1963 - 1965 Corvette: Service Bulletin: Drive Line Noise

Subject: Drive Line Noise
Model and Year: 1963 - 1965 Corvette
Source: Chevrolet Technical Service Bulletin
Bulletin No: #1069
Section: IV
Date: January 7, 1965

FIGURE 1

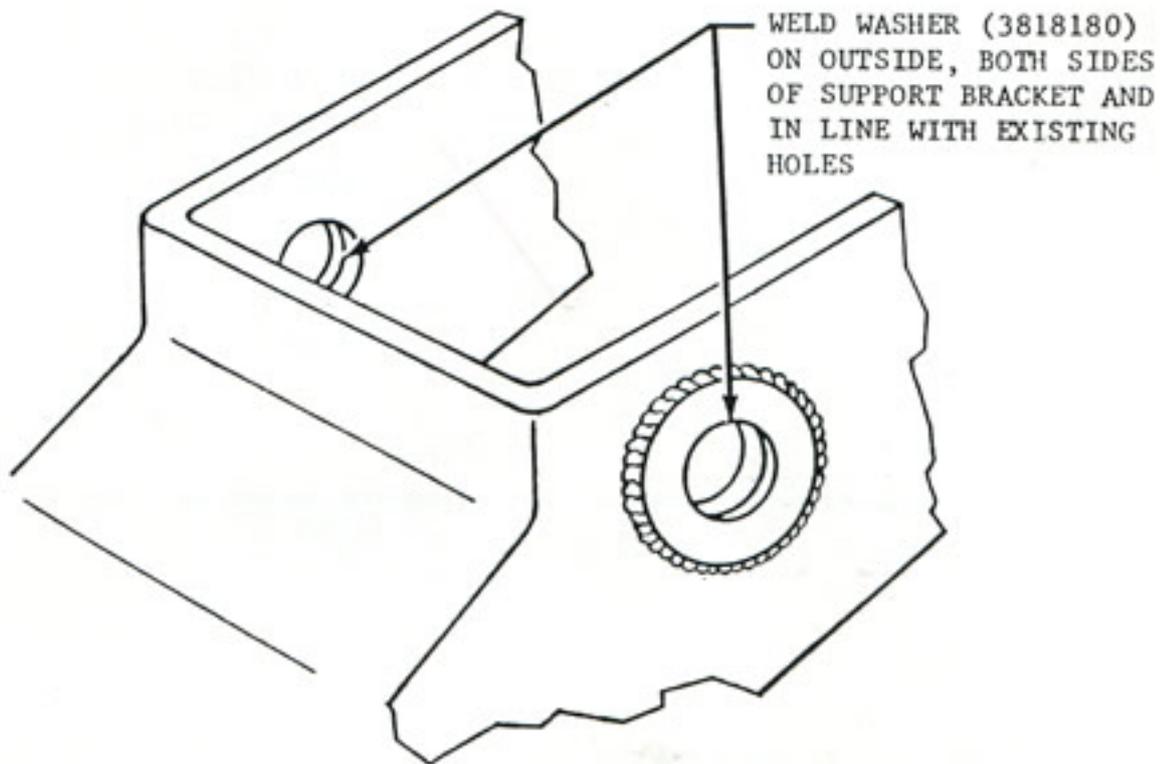
If elongation of bracket bolt holes occur, the differential carrier bracket should be replaced with bracket Part No. 3868799. However, the original service bracket Part No. 3820186, can be used by reinforcing it as shown in Part I of this bulletin. In conjunction with the installation of the bracket, it will be necessary to secure the forward attaching bolts as outlined in Part II of this Bulletin.

1. If reinforced bracket, Part No. 3868799 is not available, obtain Part No 3820186 and weld one flat washer, (Part No. 3818180) on each outside surface in line with existing holes (See Figure 1.)

FIGURE 2

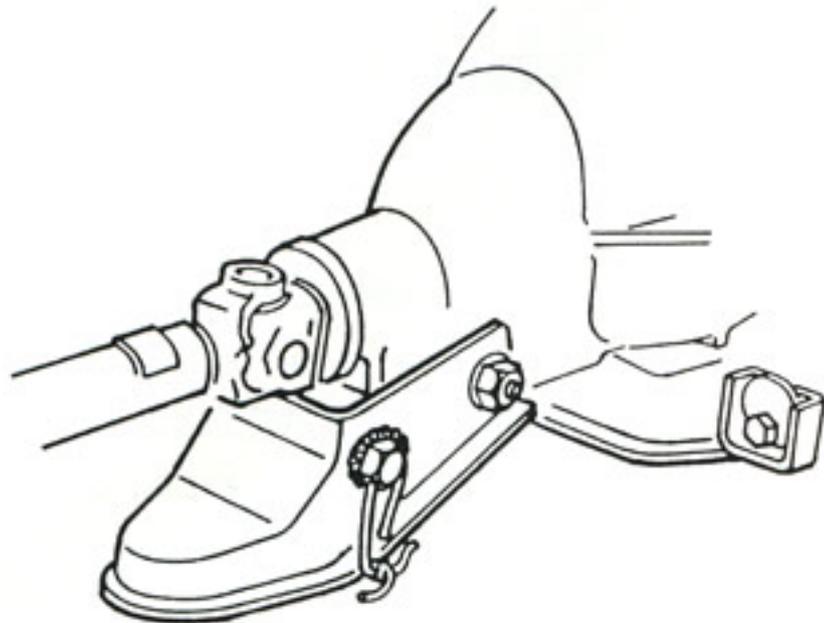
1. Obtain (2) 7/16-14 x 1 300M bolts and drill a 3/32 inch diameter hole through the head of each.
2. Drill a 3/32 inch diameter hole through the lower flange of the carrier bracket directly below the forward bolt hole (both sides of bracket).

3. Install new bracket using modified forward attaching bolts. Torque forward attaching bolts to 65 ft. lbs.
4. Safety wire the forward bracket bolts to the bracket with stainless steel safety wire (1/16 inch O.D.) or stainless steel welding rod (1/16 inch O.D.).

NOTE: Be sure the straight wire form the bolt head to the flange hole is on the tightening side of the bolt. (See Figure 2).

5. Tighten the wire sufficiently by twisting the ends together. NOTE: Over-tightening will cut the wire at sharp bends.
